# Historical Architectural Review Board COA Preliminary Review Sheet

**HDC-2025-00017**

**Address:** 627 Liberty Street

**Proposal:** Window replacement, front door replacement, installation of rear dormer, parking pad, and fence.

Existing Front Elevation (Applicant)

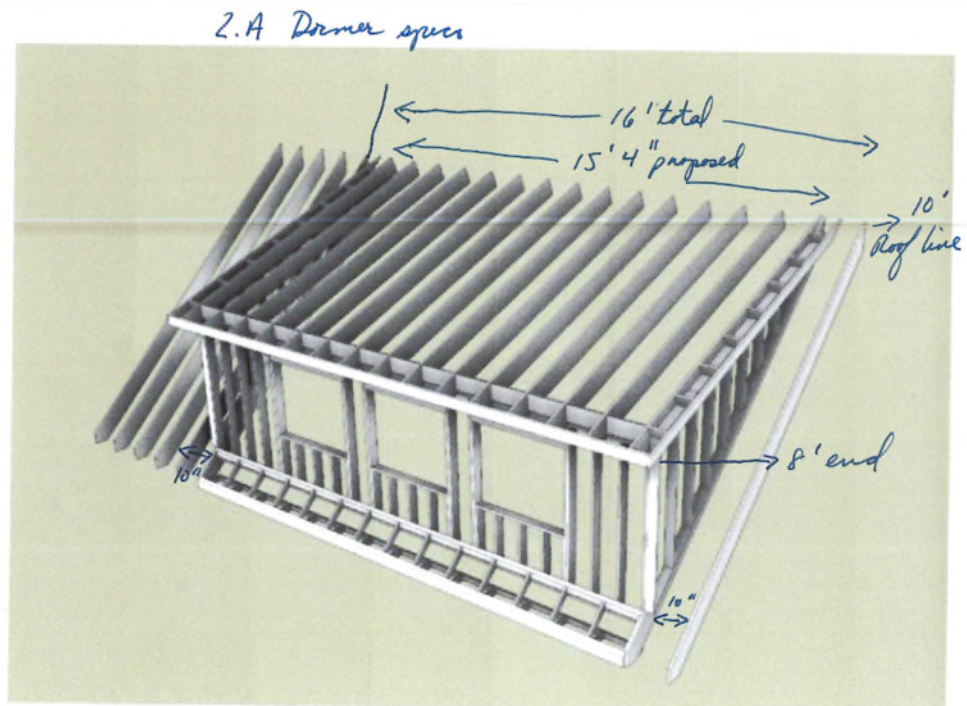
- **Four Front Window Replacement:** While aluminum clad wood is an appropriate material for replacement windows, it would be helpful to review evidence that the current windows require replacement and cannot be repaired. From available imagery it appears that the windows may be original and are in a two-over-two

- **Rear Windows:** From available imagery, the rear windows appear to be original, with original intact lintels and sills. Per 3.5.11, “if creating new openings or infilling existing ones is necessary for a project such as an adaptive reuse, locate openings on side or rear facades.” While these windows are located on a secondary façade, given the high degree of integrity of the rear second floor, it would be helpful to understand if options were explored to retain the windows while created the desired interior environment. To both infill and reconfigure existing historic windows would create adverse effects on the historic integrity of the building.

- **Four Front Window Replacement:** More information regarding the existing condition of the windows would be helpful to understand if the windows are beyond repair.

- **Rear Windows:** To both infill and reconfigure existing historic windows would create adverse effects on the historic integrity of the building; it would be helpful to understand if other options that retain the windows have been explored.

Proposed rear shed dormer (Applicant)

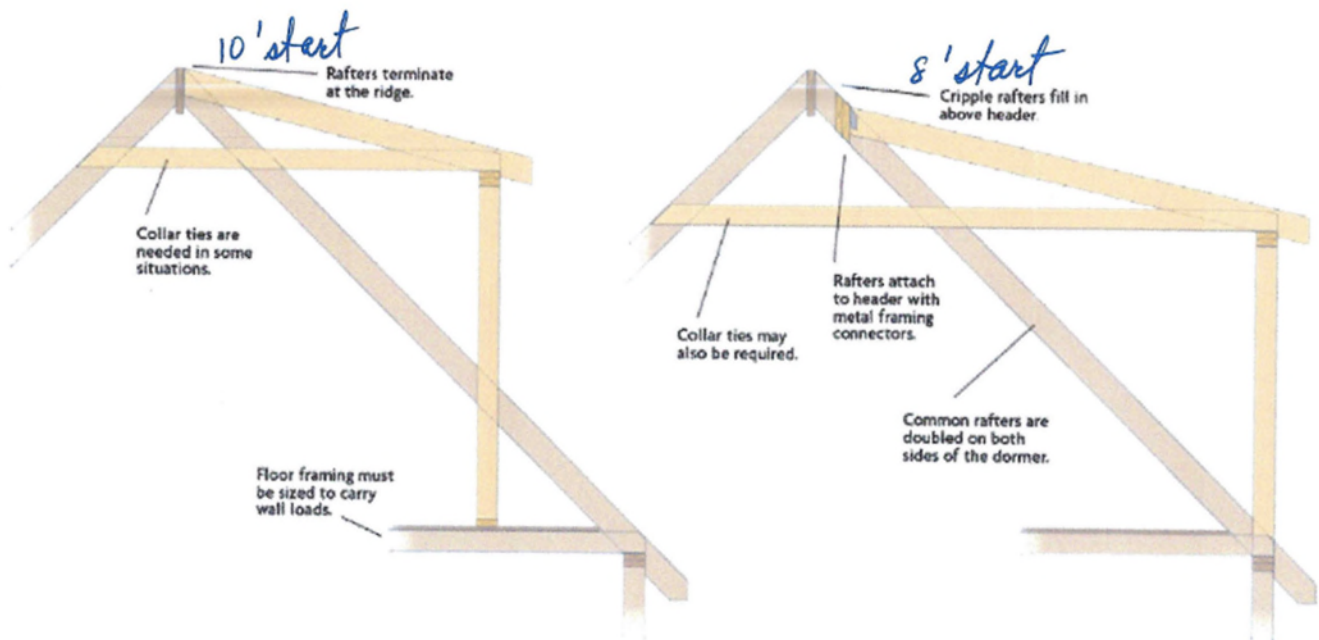
- **New Rear Dormer:** Staff reference 4.1.9, “dormer additions should not overwhelm the historic roof and should be scaled to preserve the predominance of the original roof form. New dormers are inappropriately large if they span from end to end of the original roof or if they reach from eave to ridge, or if they occupy the majority of the roof slope’s area. New dormers on primary façade are rarely appropriate” and 4.1.26 “Design new dormers to be compatible with the existing architectural style and window pattern of the main building. Locate new dormers on rear or side roof slopes to reduce visibility.”

- A dormer addition at the rear of the building is an appropriate location. There would be some visibility from Park Street, and from Pratt Street at the rear, but may not be highly visible.

- The proposed dormer does occupy a majority of the rear roof. It would be helpful to understand if it is possible to further reduce the overall width of the dormer, understanding that an existing interior stair is a limiting factor.

- The proposal indicates 2-4 windows in the dormer. In keeping with the rhythm of the building, it would be appropriate to retain one or two windows.

- **New Rear Dormer:** As proposed, the dormer occupies a majority of the rear roof. It would be helpful to understand if the scale of the dormer can be reduced. That discussion will help inform the appropriate approach to fenestration.
